# Heavy Vehicle Local Road Report Parramatta

<b>Project Name:</b>	Sydney Metro West		
<b>Client Name:</b>	Sydney Metro		
<b>Project Address:</b>	DELTA will be working at the following sites: 1. Parramatta 2. Clyde 3. Westmead		
<b>Project Description/Scope:</b>	DELTA Pty Ltd (DELTA) is responsible for the demolition of existing structures including removal of all hazardous materials and utility works of the Sydney Metro West Project at Clyde, Parramatta and Westmead		
<b>Prepared By:</b>	Name: 	Signature: 	Date: 7 <sup>th</sup> October 2021
<b>Reviewed By:</b>	Name: 	Signature: 	Date: 7 <sup>th</sup> October 2021
<b>Authorised By (Project Director):</b>	Name: 	Signature: 	Date: 7 <sup>th</sup> October 2021

### A. Received comments

Project	SSI 10038 – Sydney Metro West
Document	10038-PA-47 – Heavy Vehicle Local Road Report Parramatta – Rev 2, dated sept 22 2021
Date received from Sydney Metro	Sept 22 2021
Date comments sent to Sydney Metro	Sept 29 2021

**Figure 8: Land use - Parramatta (source: Chapter 14 Property and Land Use EIS)**

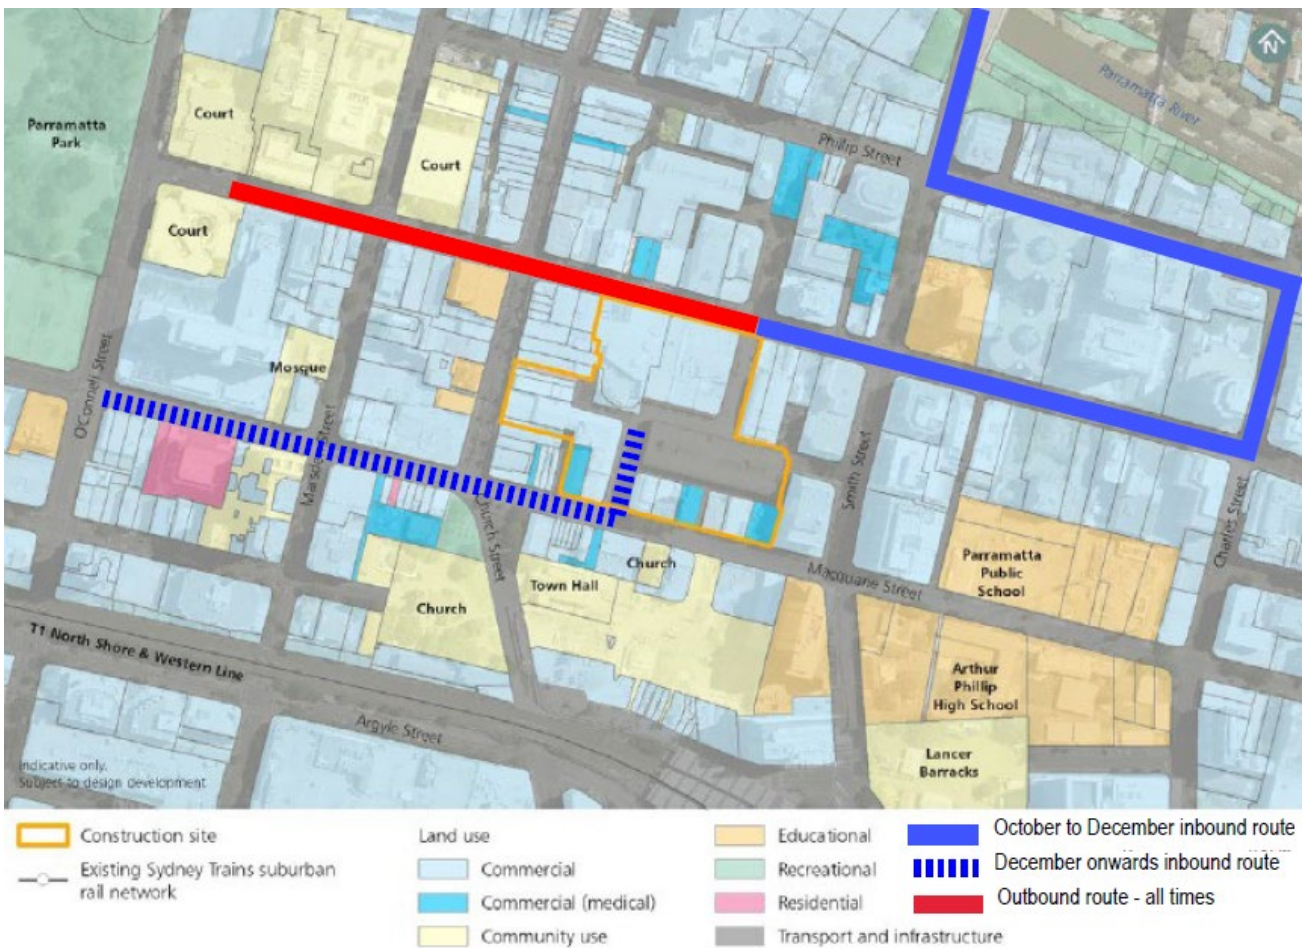
Pedestrian access will be restricted to the southern side of Macquarie Street, other than for access to the retail premises between Church Street and United Lane on the northern side of Macquarie Street	Minor Non-Compliance	N
				24	10/09/2021	SMD		SMWSDDS-DLT-PTA-TF-REP-000059	Figure 8	General Specification	This figure shows the surrounding social infrastructure, but there is no discussion/analysis on how the proposed non EIS heavy vehicles routes impact them or what the mitigations may be if they do. This does not address MCoA87(B). Update HVLR accordingly.	Minor Non-Compliance	N
								SMWSDDS-DLT-PTA-TF-REP-000059	Figure 8	General Specification	Document amended	Minor Non-Compliance	N

24.01.01	22/09/2021	SMD					Yes, the map shows existing conditions, the route proposed goes past that (and other) existing conditions. For example one of the existing conditions is Western Sydney University. Does the route proposed have an impact on students and the University? If so, what are the mitigation? That is what is required by DPIE.	Minor Non-Compliance	N
											There is no impact to Western Sydney University as it is located on Smith Street between Phillip Street and George Street which is not part of the proposed heavy vehicle route	Minor Non-Compliance	N
				37	17/09/2021	HBI		SMWSDDS-DLT-PTA-TF-REP-000059	Heavy Vehicle Local Road Report - Table 1	D87	Table 1: Ministerial Conditions of Approval requirements for HVLRMcoA D83 relevant to HV is not addressed in this Table and document. Review/update accordingly.	Actual Non-Compliance	N
								SMWSDDS-DLT-PTA-TF-REP-000059	Heavy Vehicle Local Road Report - Table 1	D87	Not applicable - refer to Schedule 20 from Sydney Metro	Actual Non-Compliance	N

24.01	20/09/2021	DLT		SMWSDDS-DLT-PTA-TF-REP-000059	Figure 8	General Specification	This section is describing Existing Conditions. As noted in the report there is no other available routes- refer to Section 8	Minor Non-Compliance	N
								SMWSDDS-DLT-PTA-TF-REP-000059	Figure 8	General Specification	Figure updated	Minor Non-Compliance	N

**Figure 17: Proposed Christmas 2021 traffic changes**

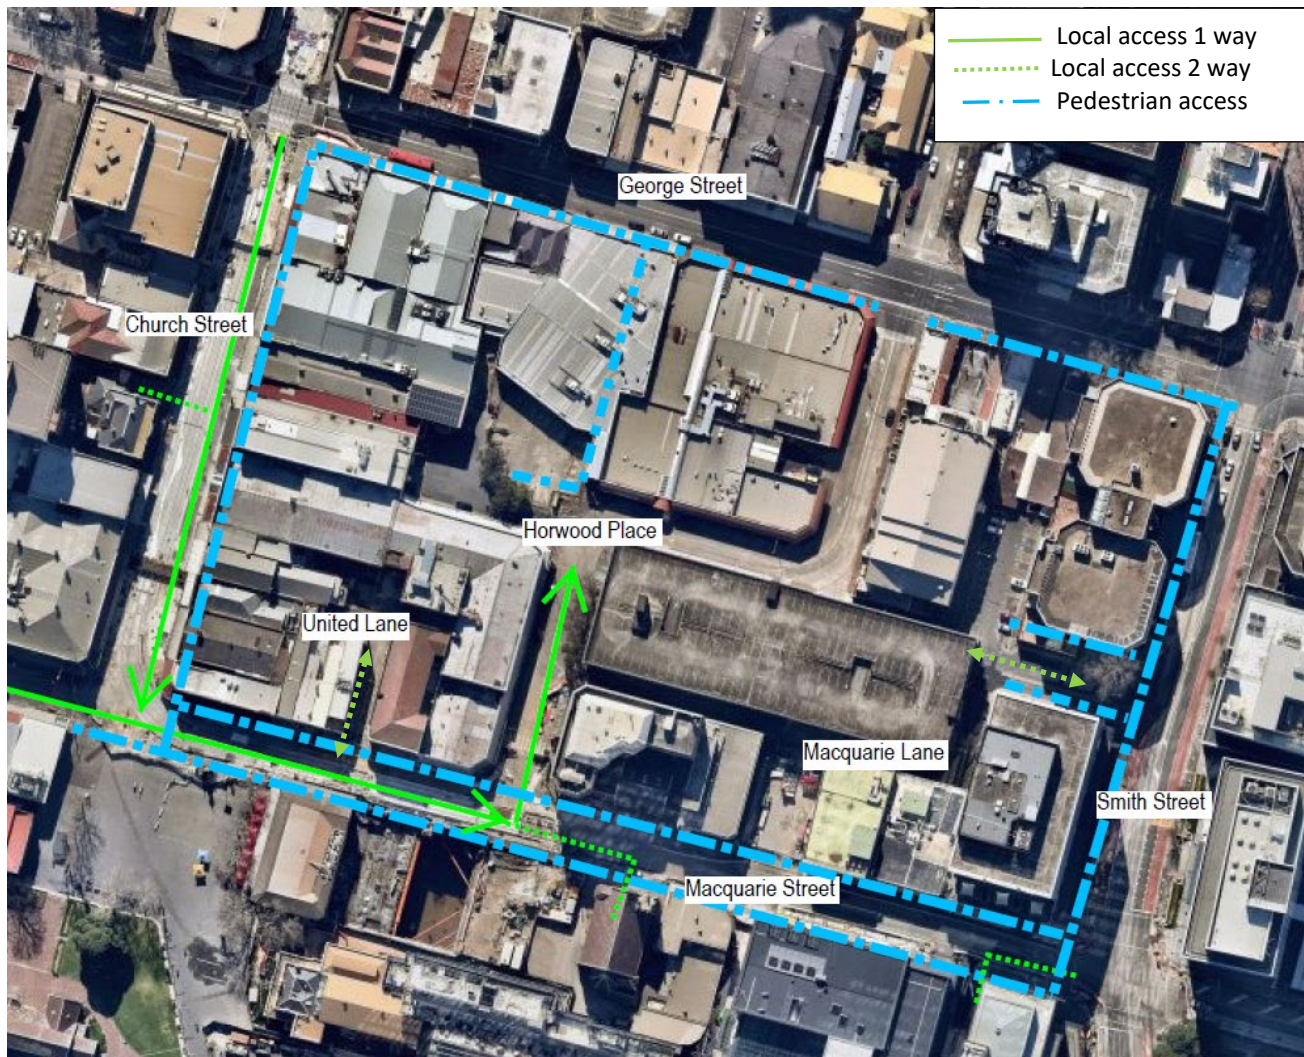
[REDACTED]	SMWSDDS-DLT-PTA-TF-REP-000059	Figure 17	2.11.1 (f) of the General Specification	This is the route provided by Sydney Metro as part of the Demolition contract award. The initial route (Sept to Dec) is a compromise route to allow all works as noted in section 8.2 and as noted in section 8.3. Pedestrians will be maintained on the southern footpath of Macquarie Street only removing the interface between vehicles and pedestrians at the intersection of Horwood Place and Macquarie Street	Minor Non-Compliance	N

12.01	20/09/2021	DLT	[REDACTED]	SMWSDDS-DLT-PTA-TF-REP-000059	Figure 17	2.11.1 (f) of the General Specification	This is the route provided by Sydney Metro as part of the Demolition contract award. The initial route (Sept to Dec) is a compromise route to allow all works as noted in section 8.2 and as noted in section 8.3	Minor Non-Compliance	N
							[REDACTED]	SMWSDDS-DLT-PTA-TF-REP-000059	Figure 17	2.11.1 (f) of the General Specification	This is the route provided by Sydney Metro as part of the Demolition contract award. The initial route (Sept to Dec) is a compromise route to allow all works as noted in section 8.2 and as noted in section 8.3. Pedestrians will be maintained on the southern footpath of Macquarie Street only removing the interface between vehicles and pedestrians at the intersection of Horwood Place and Macquarie Street	Minor Non-Compliance	N
